# KRn return loss and test fixture

# Some related issues with -KRn spec

1. 50GBASE-KR, 100GBASE-KR2, and 200GBASE-KR4 test fixture return loss is not compatible with tightened return loss spec
  2. -KRn return loss spec is too tight at low frequencies
- Comments 137, 141

# COM is not consistent for RL

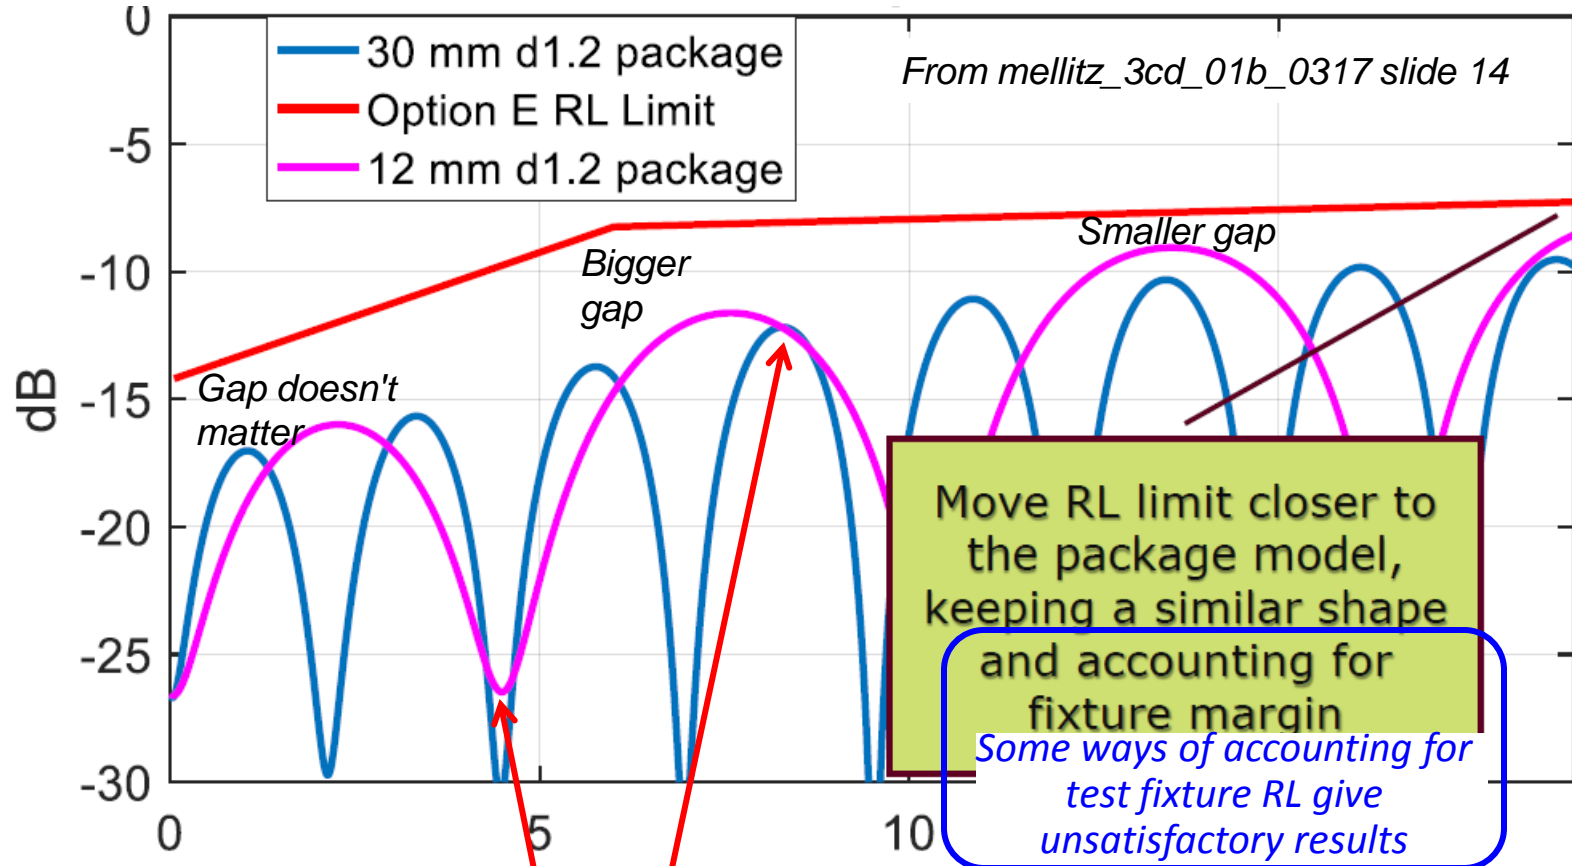
- A channel reflection at this frequency degrades that channel's long-package COM
  - as it should
- A channel reflection at this frequency is pretty much ignored by COM
- A channel RL spec is useful because it treats reflections consistently with frequency

# Comparing "nominal" return loss limits

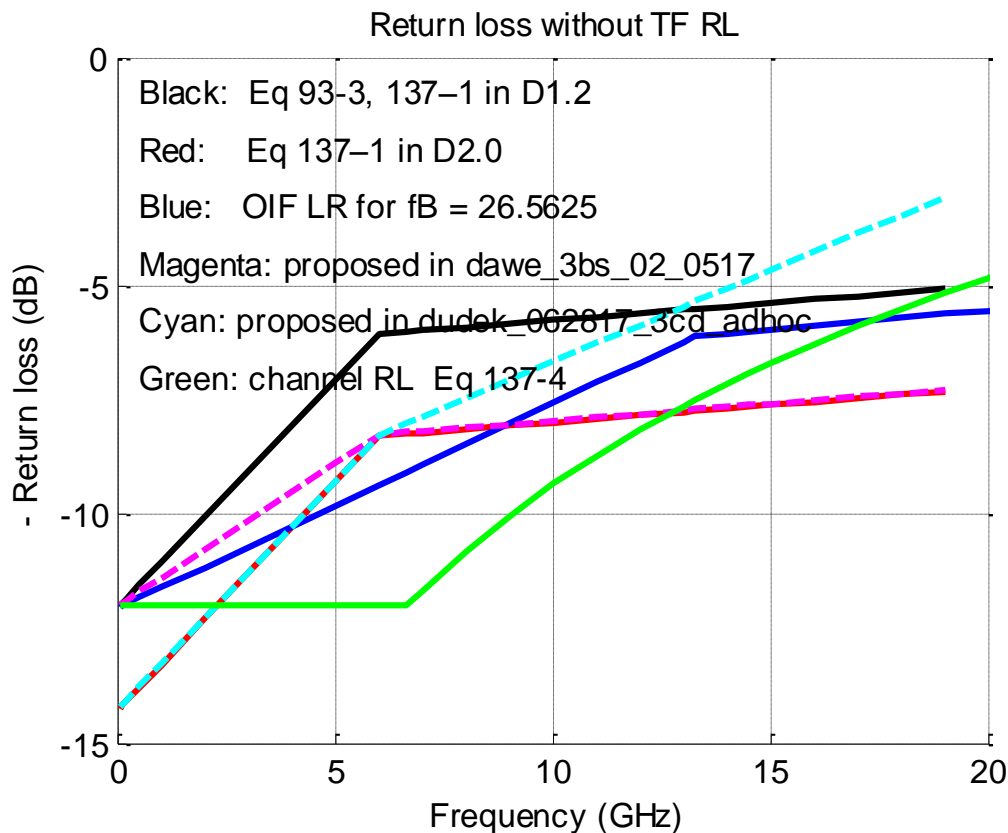
- D2.0 is unusually tight at low  $f$
- If OIF is even half right, the limit should be straighter
- Channels have lower return loss than this at very low frequencies – but that doesn't mean we need to adjust the spec there. It appears that the older specs were set on the basis that 12 dB is good enough

# Adjusting for test fixture IL but not its RL

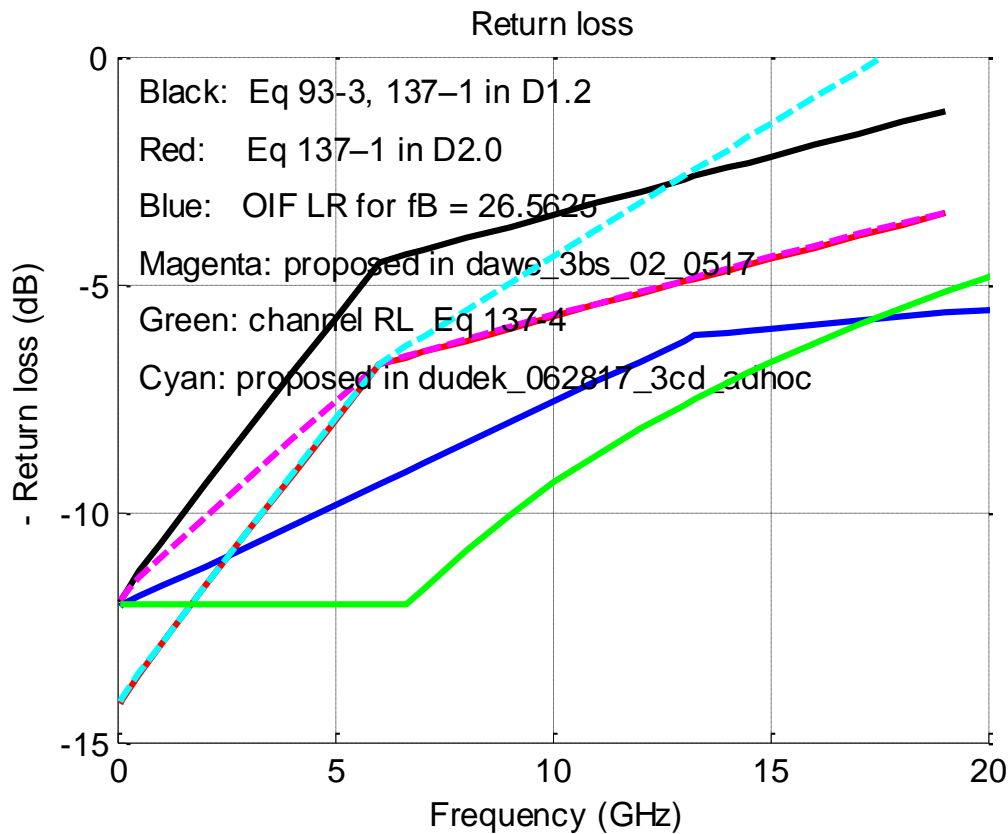
- Compare previous slide
- IL of test fixture makes a big difference
- Red and cyan are too tight at low  $f$
- Cyan is too loose at high  $f$
- Black is too loose at mid  $f$
- Above 3 GHz, OIF limit is tighter than all the 802.3 ones – but are the 802.3 ones deliberately relaxed to allow for the test fixture?

# 1. Backplane/C2C test fixture RL

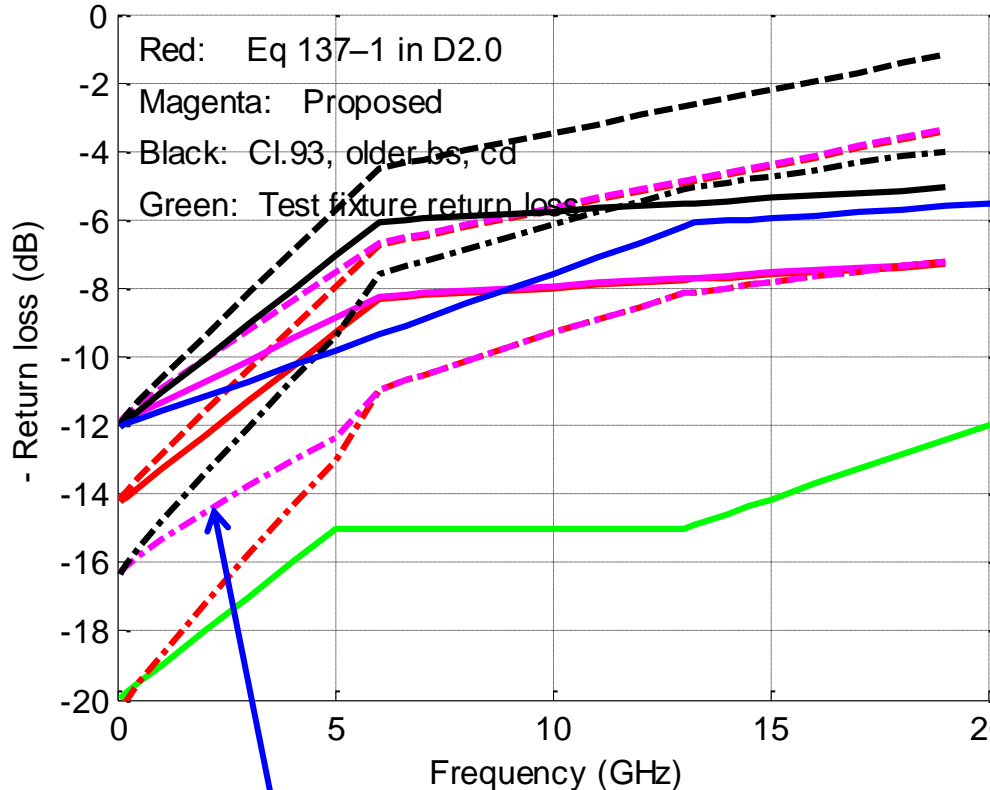
If the apparent RL is given by the solid lines, and the test fixture has allowed reflections per green line, the IC on the test fixture has to be **much** better than intended

Changing from black to red made this issue worse

The problem is worst at low frequencies, and for the red and cyan lines (cyan not plotted)

*The gap between spec RL and TF RL is too small*

**De-embed the return loss differences, or tighten the TF RL spec?**
